MEMORANDUM

Date: September 21, 2018

Re: Proposed alignment of a multi-use path between Fordham Blvd and Hickory Drive from Ridgefield Road to Willow Drive

Figure 2. One way intersections along Raleigh Rd

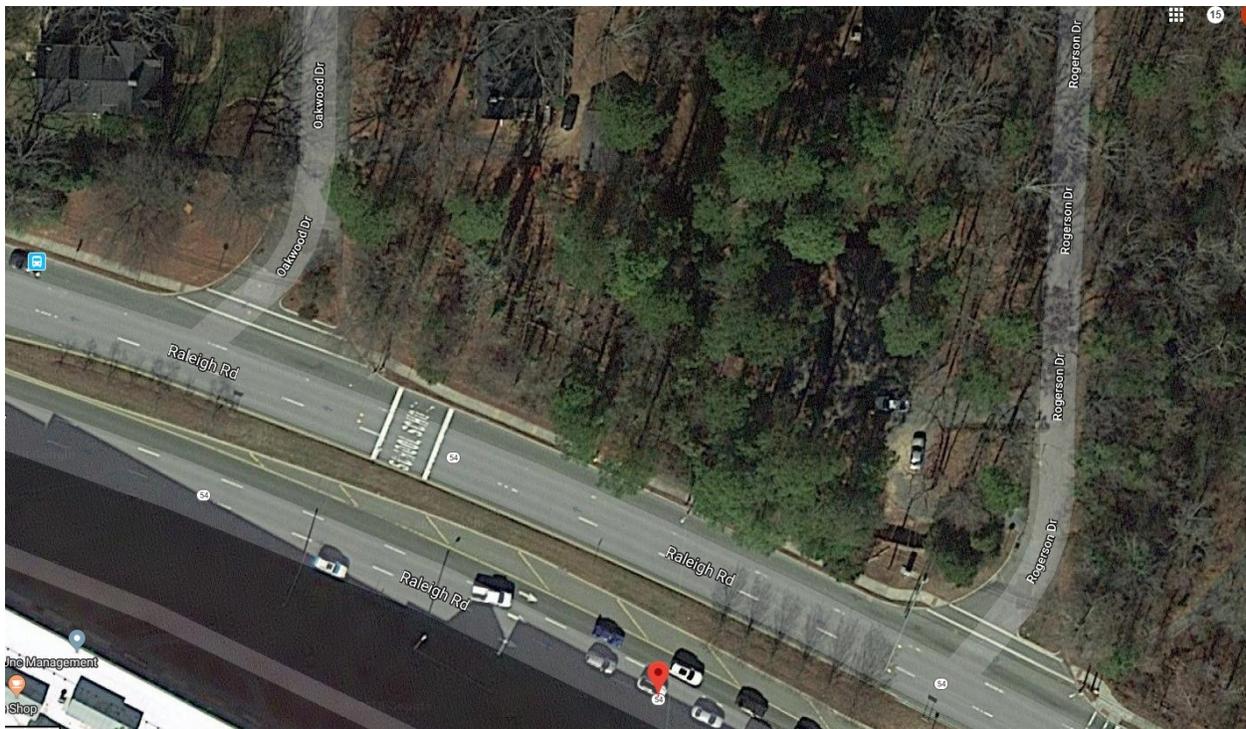
A second-best alternative would be to eliminate motor vehicle right turns at Ridgefield and Walnut, as has been done for Rogerson Rd and Oakwood Drive at Raleigh Rd (Figure 2), and proceed with either the multi-use path as proposed. This approach would only address conflicts between motorists turning from Fordham onto the side streets, however, and would do nothing to address the conflict between south-bound path users and vehicles exiting the Little Ridgefield neighborhood. As this conflict pertains largely to cyclists and users other higher speed non-motorized modes, a modification to the second-best alternative would replace the multi-use path between Ridgefield and Willow with a pedestrian-only sidewalk, and direct cyclists and other higher speed users along the existing facility on Hickory.
